# Modification of Development Consent

## Section 96(1A) of the *Environmental Planning and Assessment Act 1979*

<b>Application No:</b>	SSD 7075
<b>Applicant:</b>	Cleanaway Pty Ltd
<b>Consent Authority:</b>	Minister for Planning
<b>Development:</b>	<p>Erskine Park Waste and Resource Management Facility Staged Development Application, comprising:</p> <ul style="list-style-type: none"><li>• A concept proposal for a Waste and Resource Management Facility (WRMF) with a maximum processing capacity of 300,000 tpa. All waste received at the WRMF shall enter the Waste Transfer Station (Stage 1), up to 150,000 tpa of this waste may be recycled at the Resource Recovery Facility (Stage 2).</li><li>• Construction and operation of the Stage 1 Waste Transfer Station with a maximum processing capacity of 300,000 tpa.</li></ul>
<b>Date of Original Consent:</b>	4 October 2016
<b>Modification:</b>	SSD 7075 MOD 1 – Modifications to the development staging, car and truck parking, the office, the load-out bays, the stormwater management system, site levels and landfill ramps.

Erskine Park WRMF  
(SSD 7075 MOD 1)

# APPENDIX 1B – STAGE 1 SITE LAYOUT PLAN

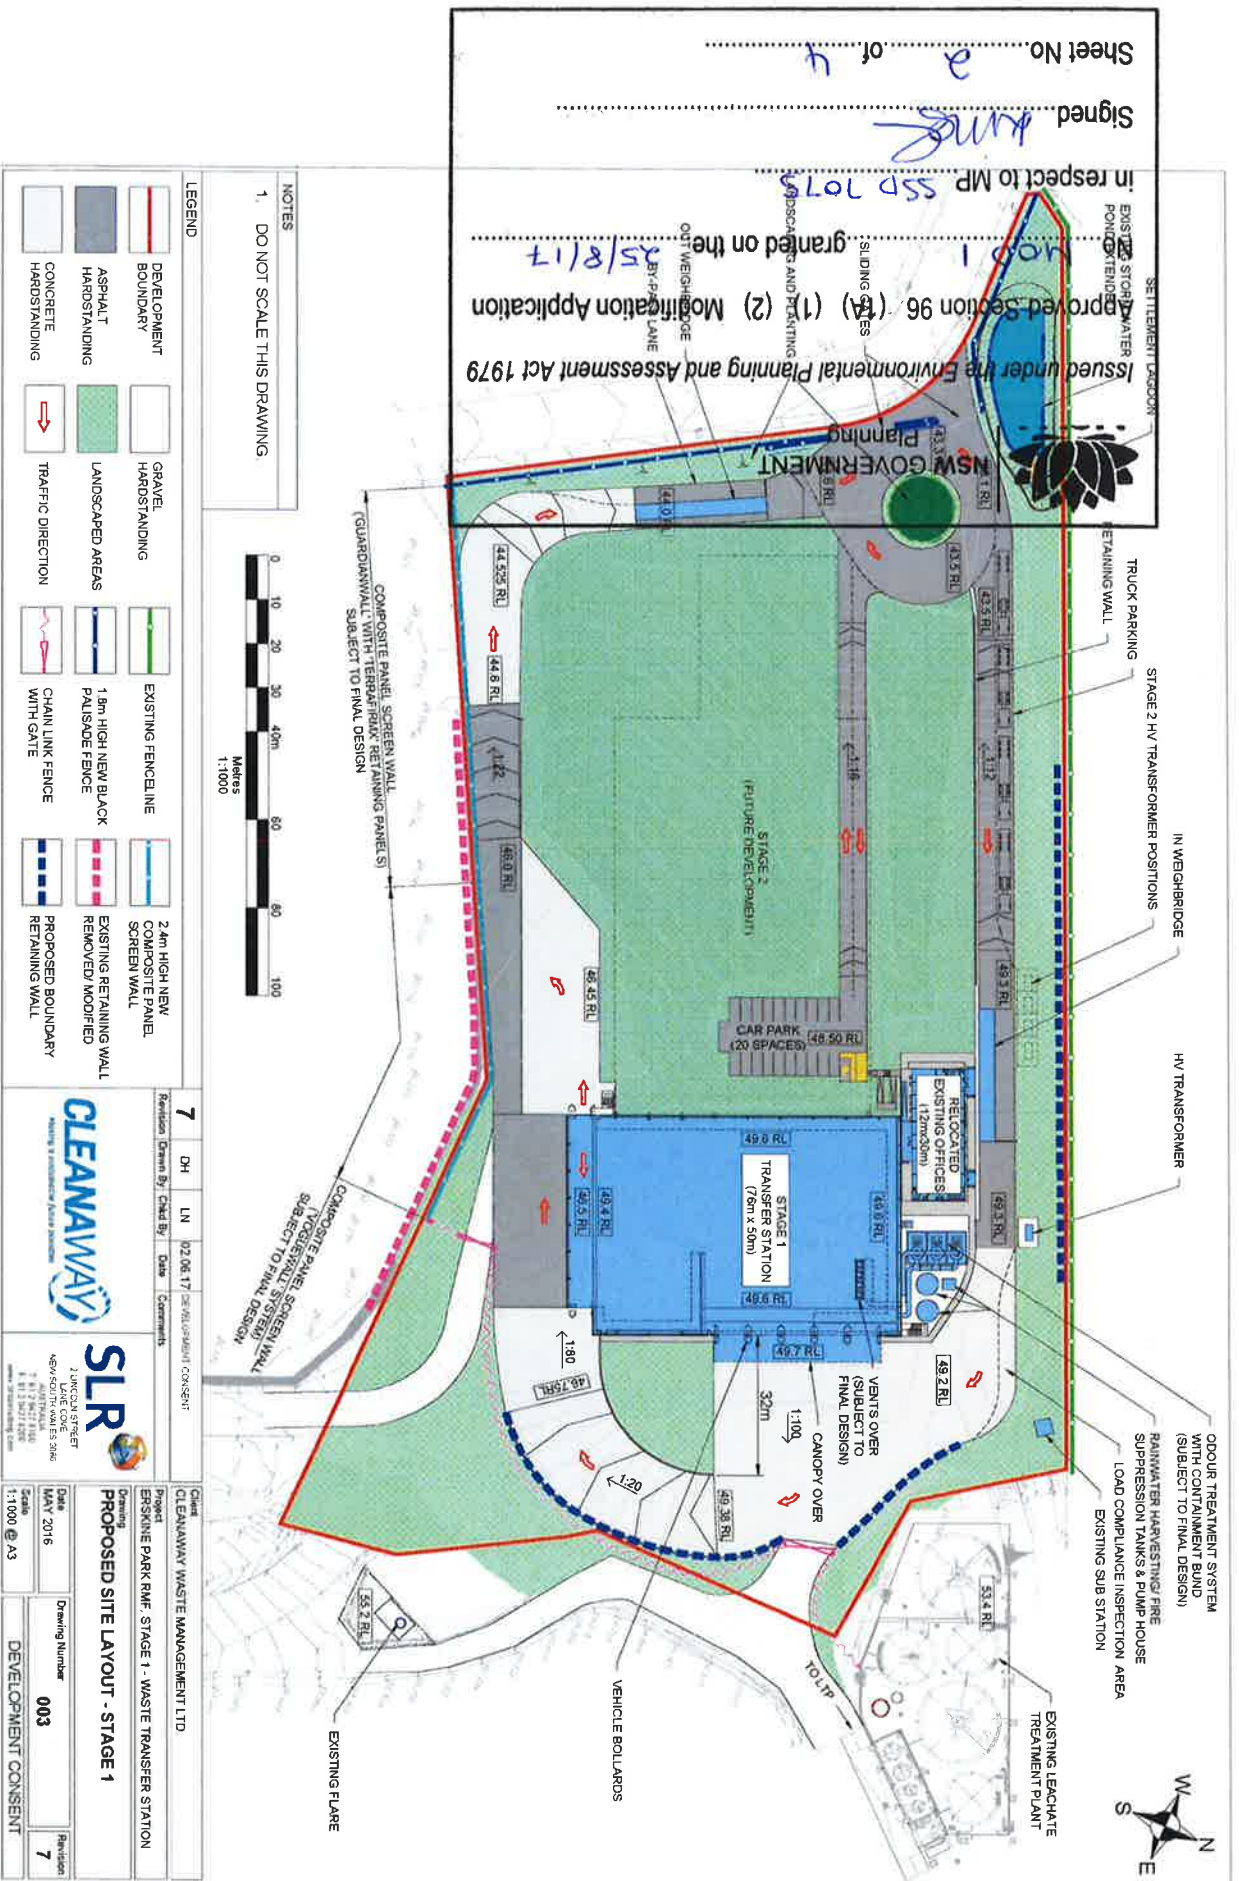
- 7. Replace Appendix 1 with new Appendix 1A and Appendix 1B.
- 8. Replace Appendix 2 with new Appendix 2.
